Chemung County Stormwater
Construction Inspection
Erosion and Sediment Control

Project Name LECOM	Date 11-14-2019
Location Park Ave Elmira (City), NY	Permit # NYR11E617
Weather Conditions overcast, cold	Entry Time: 9:02 am
On-Site Representative Present: Brian Atwater	Exit Time: 9:48 am

PROJECT: LECOM
City of Elmira
Municipal Construction Inspection
November 14, 2019

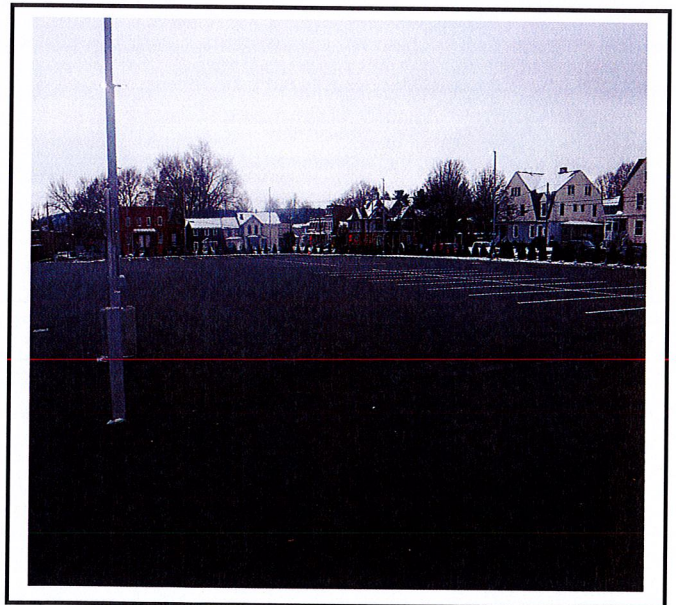
Erosion controls removed along Clinton Street. Sediment is being tracked into the road.

Erosion controls along Park Place have been removed. Equipment is tracking sediment into the road.

North-east water quality unit is not sitting straight up and down. It has also not been grouted correctly.
